DEVIATION REQUEST AND DECISION FORM

Project Name : Crawford Apartments
Schedule No.(s) : XXXXXXXXX
Legal Description : XXXXXXXXXXXXX

The requested deviation is for left turn lane length criteria (ECM Standard 2.3.7.E.2 & 3)

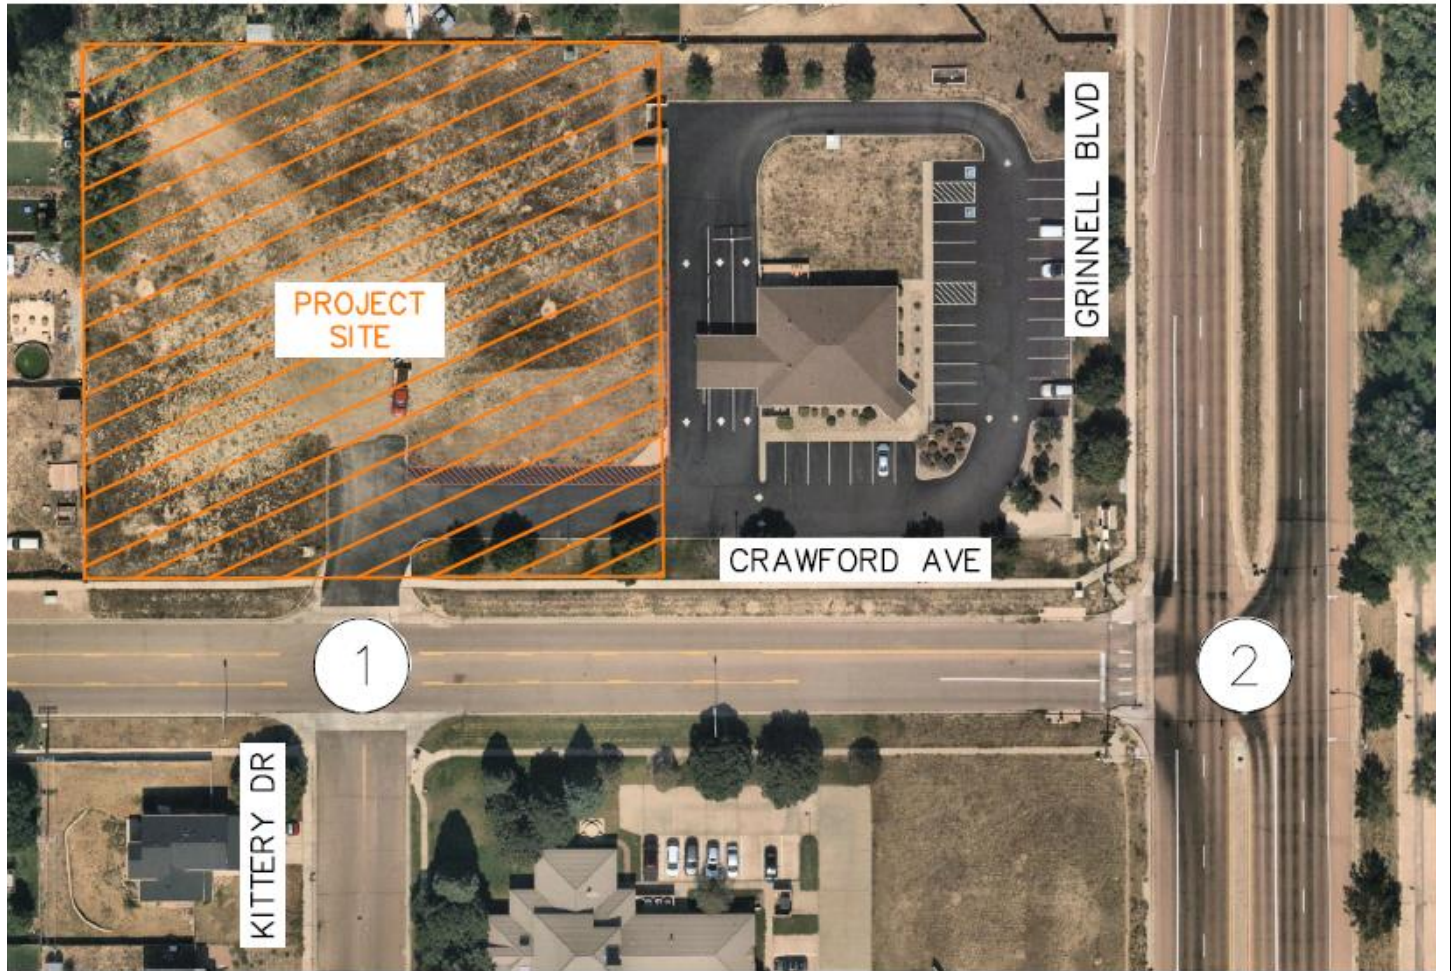
Revise deviation request to provide another agency's criteria that might provide justification for not extending the northbound left turn lane. Reference ECM 5.8.3 for more guidance. If justification is not provided as to why it is acceptable to leave as is, deviation may be denied. In the case that the deviation is denied, submit CDs for improvements necessary.
